Clarification: Additions To Ash Fork Project.

Please find your IFB questions below with Matrix/Ash Fork responses included.

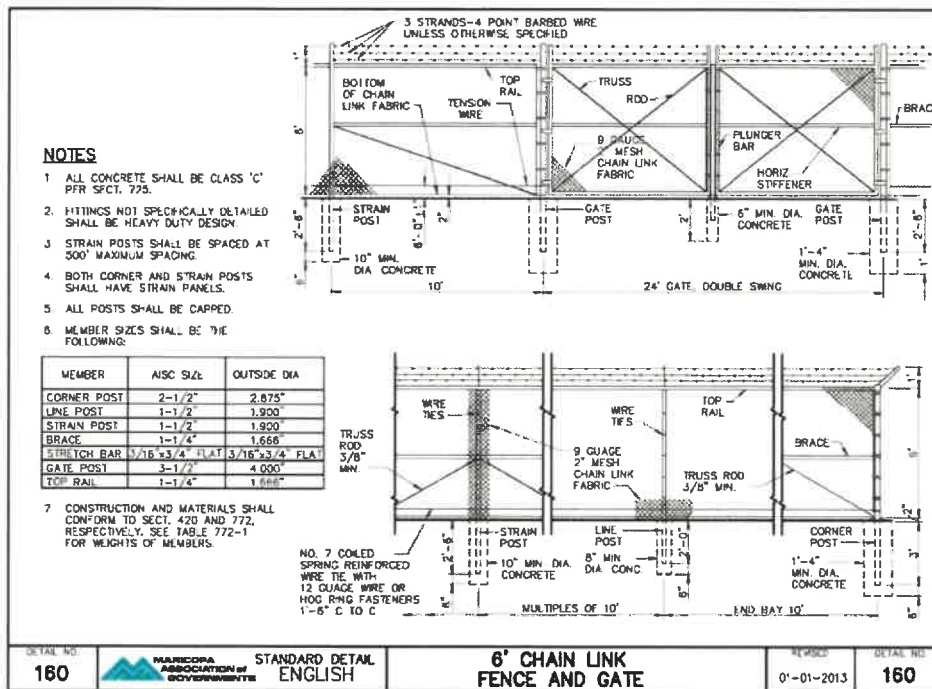
- Will survey/staking of the proposed waterline route and as-built survey be required?
 - Yes, please include survey staking.
- Should I assume this same fencing detail (MAG160 w (2) 20ft 2-panel gates) that was provided on the plans of the Buckeye project? Include barbed wire?
 - Yes, please assume the same fencing detail (see below) and for costing purpose, please assume barbed wire is required.
